Exhibit 1

Amendment to BNPFT-20180129ABG
Change Operating Parameters
Auction 100– MX Group 46
Facility ID No. 202662

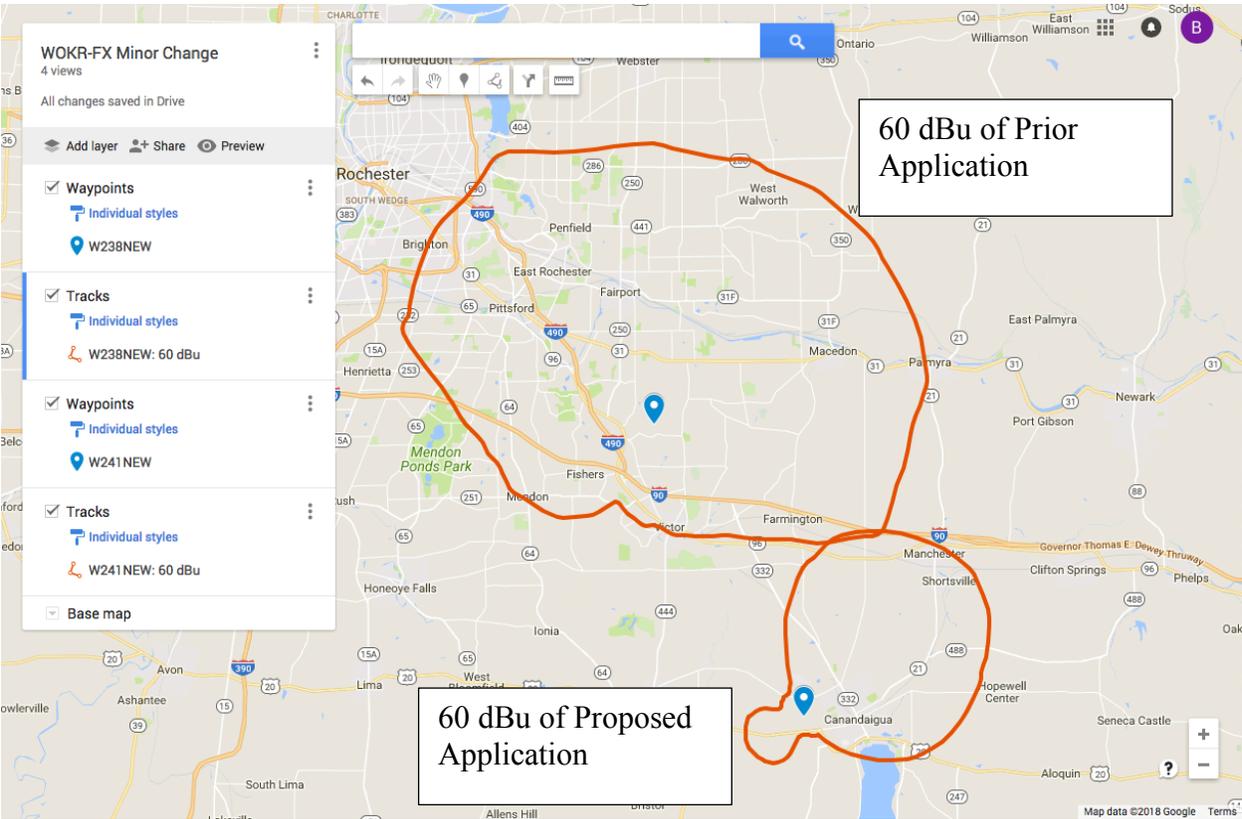
The original output channel of the application in MX Group 46 was specified to be 96.1 MHz (channel 241). This application amends the frequency to 95.5 MHz (channel 238), three channels below the original frequency.

Applicant is requesting a new location for the transmitting antenna. At this location with the operating parameters specified, the 1 mV/m contours have an area of shared coverage due to their overlap. This is depicted in the map below. This exhibit demonstrates that conditions of CFR 74.1233(a) are met with this amendment.
